37/3-96D 7109 Cedar Avenue  
(Takoma Park Historic District)

## HISTORIC PRESERVATION COMMISSION STAFF REPORT

Case Number: 37/3-96D

PROPOSAL: Install 2 skylights

PLANS  
7109 CEDAR AVE.  
TAKOMA PARK, MD

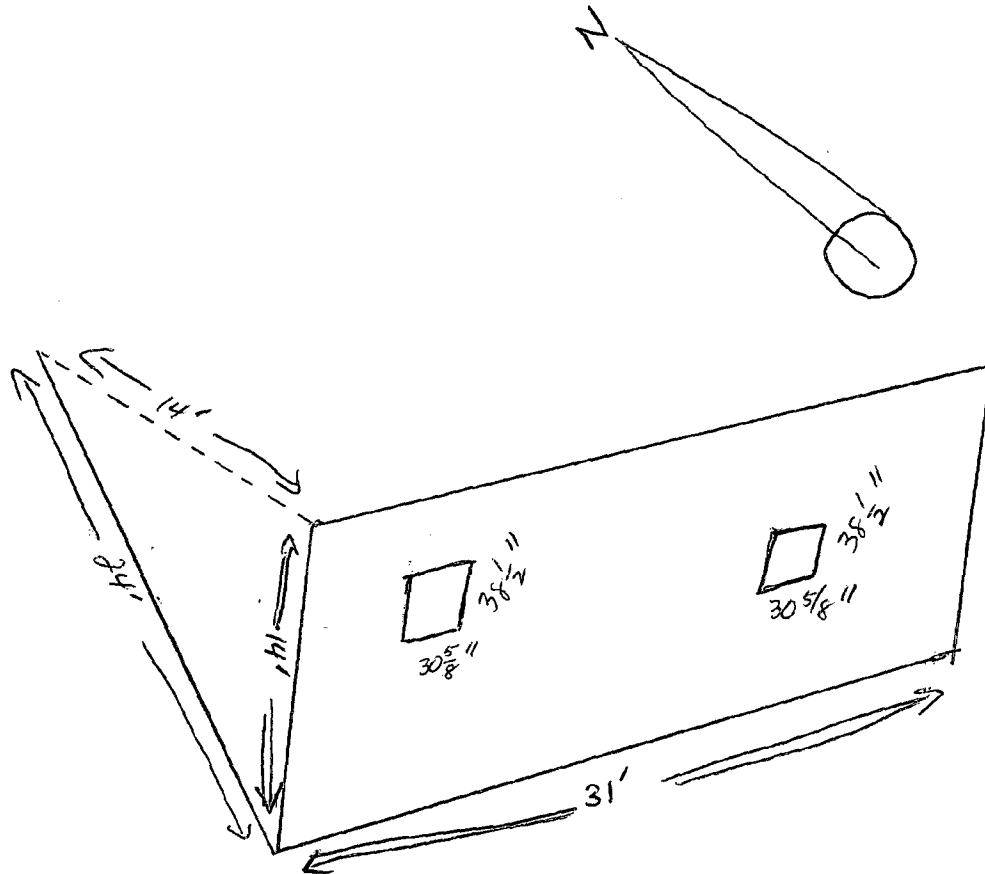
1.) All metal parts of the skylights shall match the roofing material.

2.) The forward most skylight shall not be closer than 8' from the end of the roof.

As a suggestion, but not a condition of approval, staff asks that the applicant consider moving the skylights as far to the rear of the house as possible; or even possibility deleting the skylight most forward on the roof.
